### Clarksburg Ten Mile Creek Sewer Study

### Clarksburg/Ten-Mile Creek Citizens Advisory Committee

### August 20, 2015

### TMC Sewer Alternatives – Environmental Analysis

#### EGAN/MATTLYN

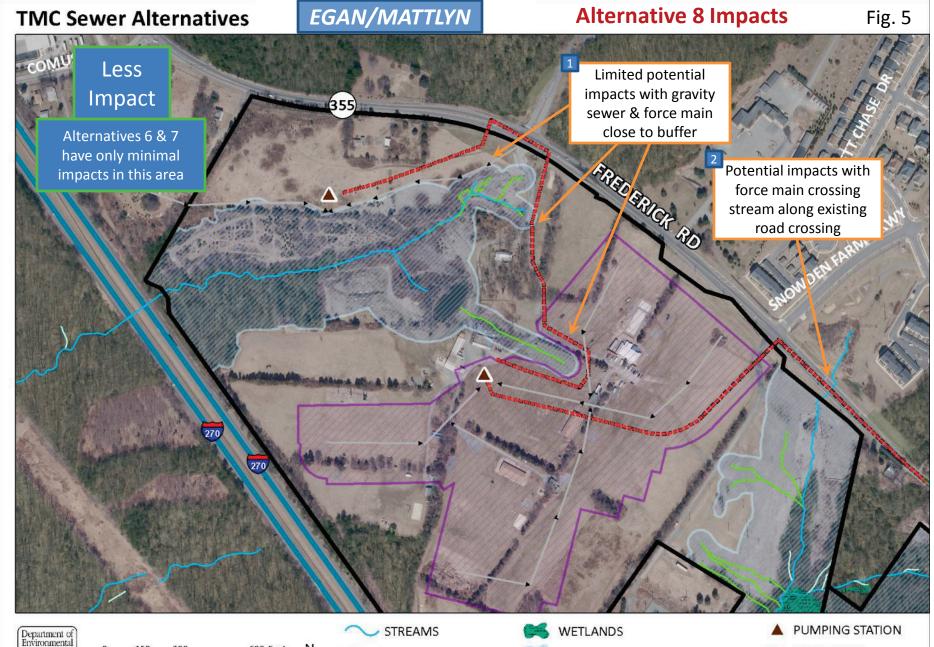
#### **Alternative 7 Impacts**

Potential impacts with trunk sewer crossing stream along existing road crossing

Alt 7 has no impacts in this area-- compared to Alt 6 & 8

Change to pressure sewer here doesn't appear to make significant difference (between Alt 6 & 7) with no impacts to any known specific features

### Specific Comments Alternatives 6, 7 & 8 – Egan/Mattlyn

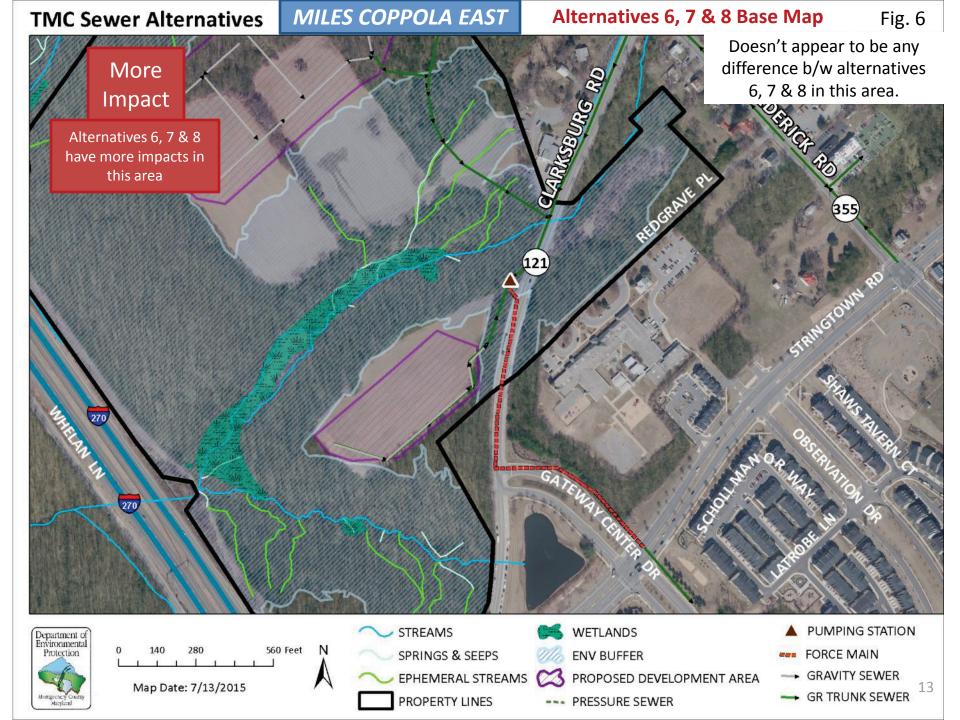
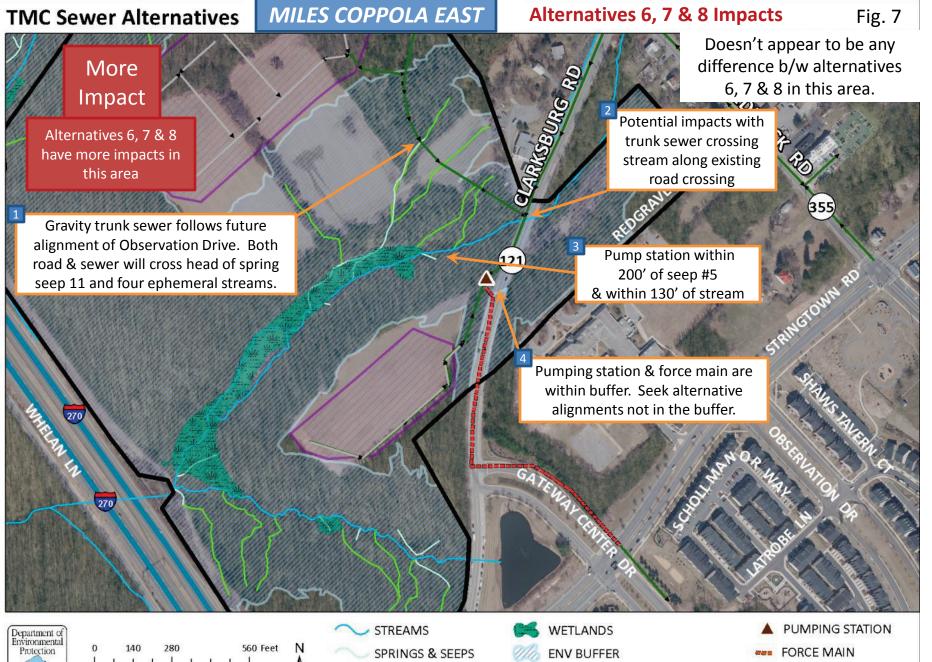
- On the Egan/Mattlyn property, Alternative 7 appears to have least impact compared to Alternatives 6 & 8.
- All three alternatives for the most part, are aligned outside of the environmental buffers, and environmental impacts appear to be minimal.

### Specific Comments Alternatives 6, 7 & 8 – Miles Coppola East

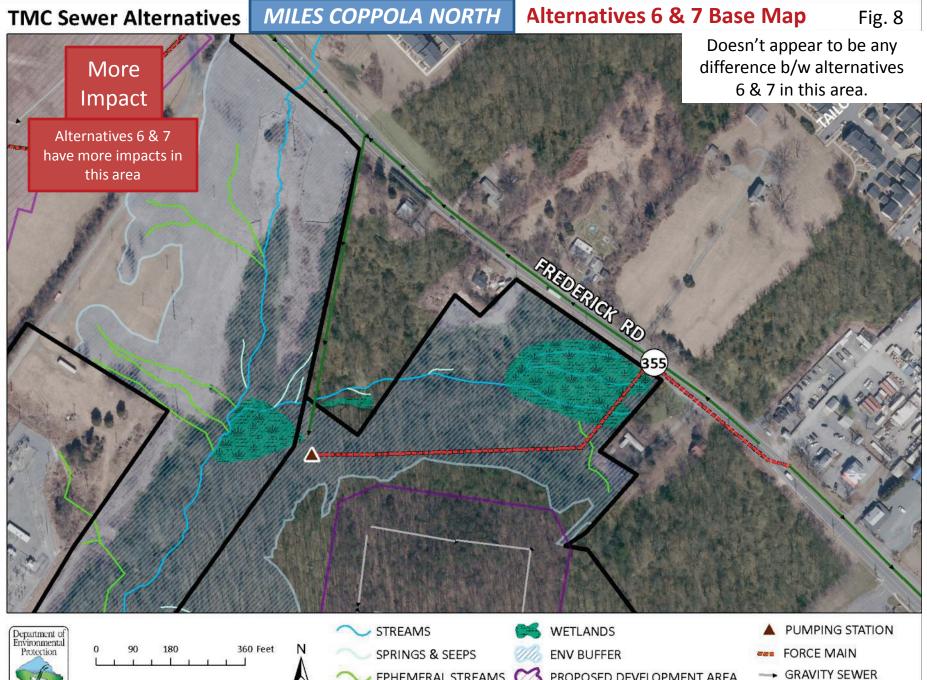
- In the East portion of the Miles Coppola property, Alternatives 6, 7 & 8 show a gravity trunk sewer that follows the proposed alignment of Observation Drive. Both the road and sewer will impact a spring seep and four ephemeral streams. Because these features feed into an extensive downstream floodplain wetland (Fig. 7, #1) impacts to these features may indirectly impact this wetland.
- Force main, pumping station and additional gravity trunk sewer are also within the buffer(Fig. 7, #s 2-4).

### Specific Comments Alternatives 6, 7 & 8 – Miles Coppola North

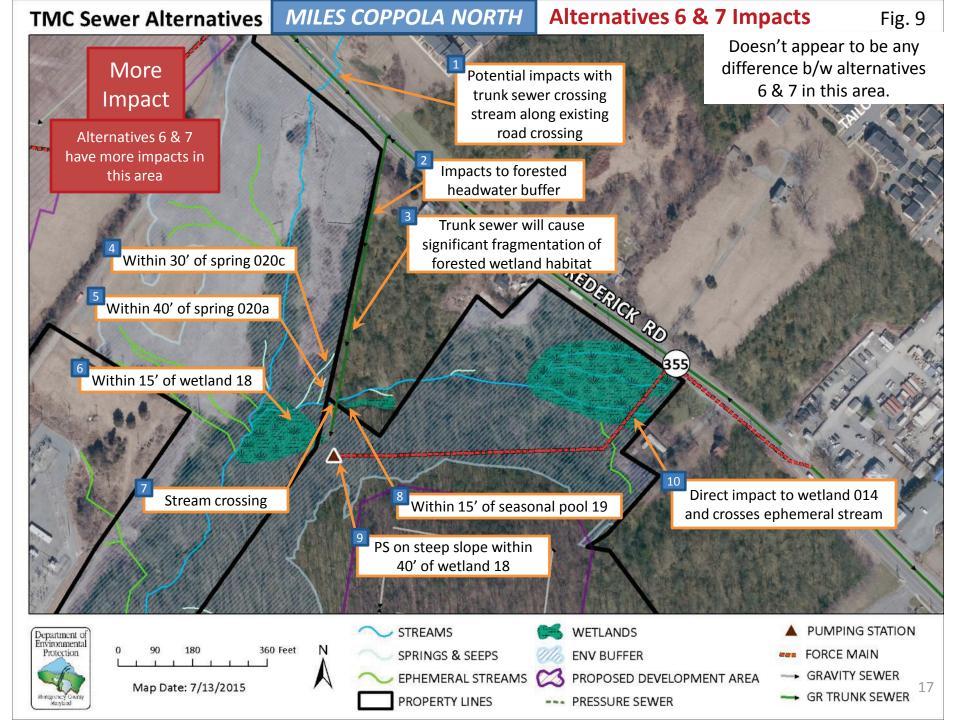
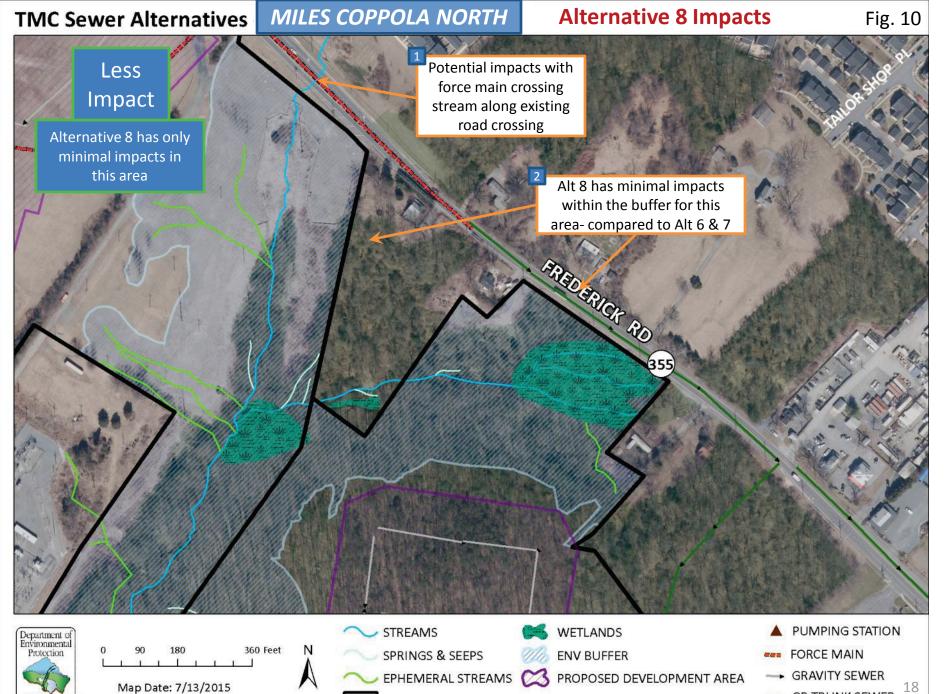
- In the Northern portion of the Miles Coppola property, Alternatives 6 & 7 show a Gravity Trunk sewer that goes directly through a complex of headwater stream, springs, wetlands/seasonal pools. Force main is also within the buffer, with direct impacts to a wetland and with pumping station proposed on a steep slope just above a wetland (Fig. 9).

- Deforestation and excavation would have possible significant impacts on these features, with disturbance to hydrology, soils, and vegetation. Proposed removal of tree canopy will increase sunlight to the forest floor and potentially cause drying of wetlands. Disturbance of the forest may also introduce invasive species.

- There will also be long term effects for this specific area. Utility conduits and tunnels can act as preferential flow channels for groundwater (Sharp et al., 2003), and features like springs, seeps and wetlands may lose their source of groundwater. Cracked pipes can also leak to groundwater, causing water quality impairment (Springer, 2009).

- In addition to individual feature impacts, impacts to this system of closely related, clusters of seasonal pools and wetlands would also likely be caused by habitat fragmentation. This cluster of streams, wetlands and seasonally flooded areas serve as critical breeding habitat for highly specialized amphibians and other indicator wetland and seasonal pool species. Many of these species travel more than 1000 feet in all directions to and from their breeding pool and are very susceptible to habitat fragmentation (Fig. 9, #3).

- Alternative 8 minimizes impacts in this Northern portion of the Miles property (Fig. 10), compared to Alternatives 6 & 7 (Fig. 9).
